## STERLING RANCH EAST FILING 6 REZONE AND PRELIMINARY PLAN

### LETTER OF INTENT

SEPTEMBER 2024

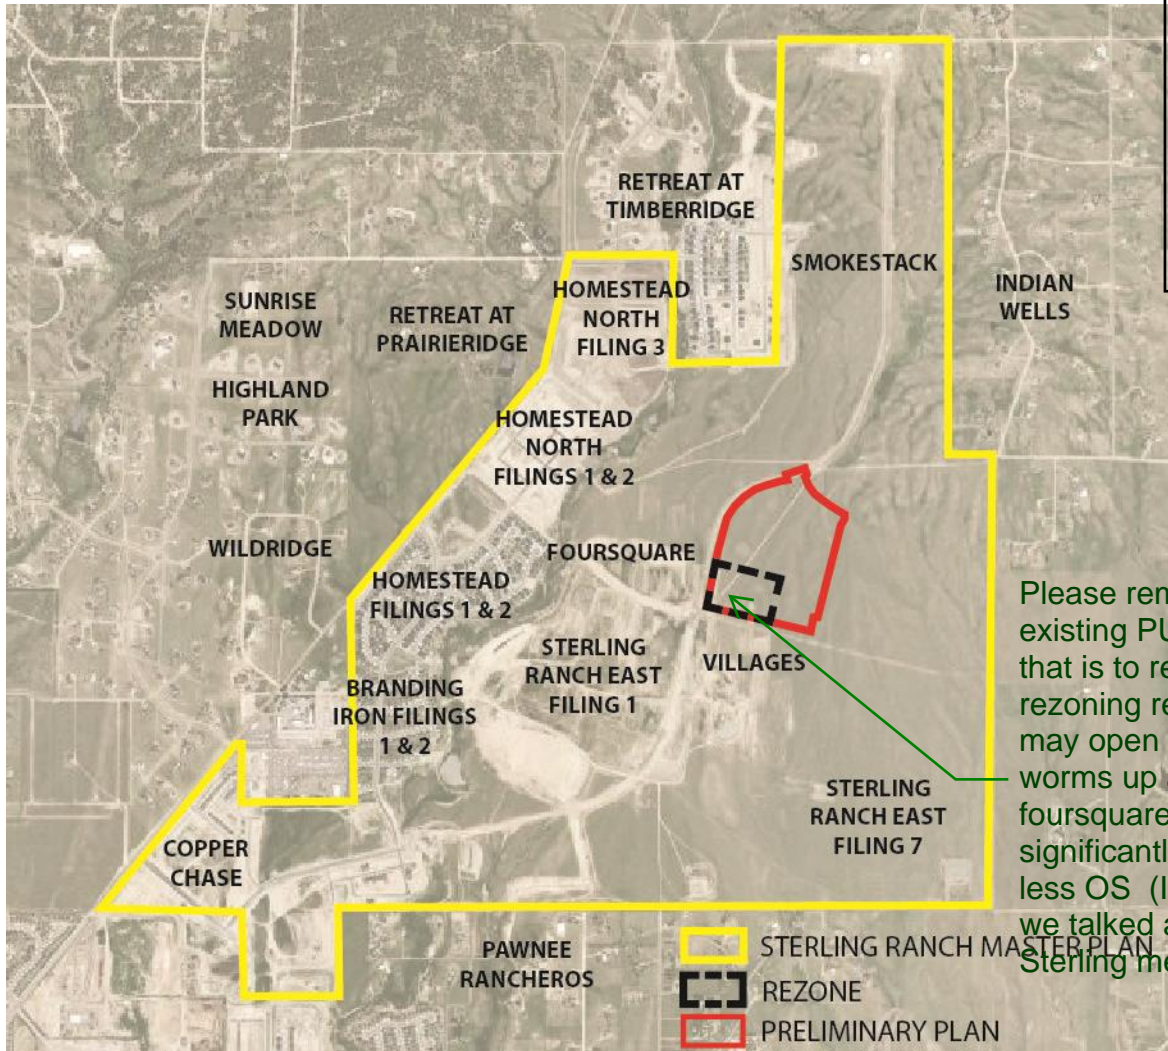
remove pond that is zoned PUD and counts as towards OS /part of foursquare; theres a trail also there.

### ZONING CONTEXT

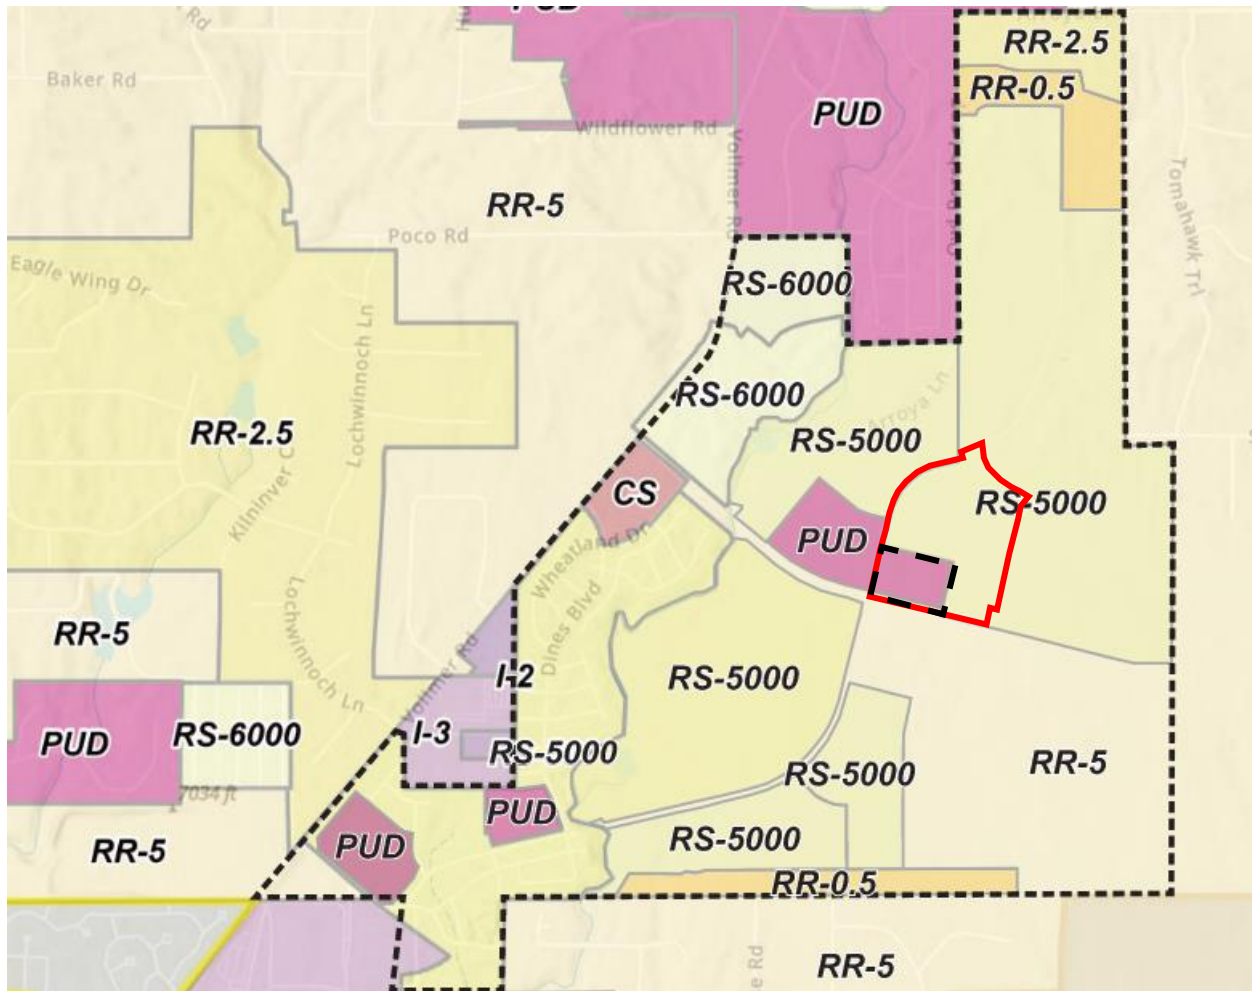
Please remove the existing PUD pond that is to remain from rezoning request: it may open a can of worms up about foursquare significantly having less OS (I thought we talked about that a Sterling meeting?)

Please add sentence or 2: PUD with Foursquare and counted towards OS but removing this amount still leaves Foursquare at % of OS meeting Code or not meeting Code?
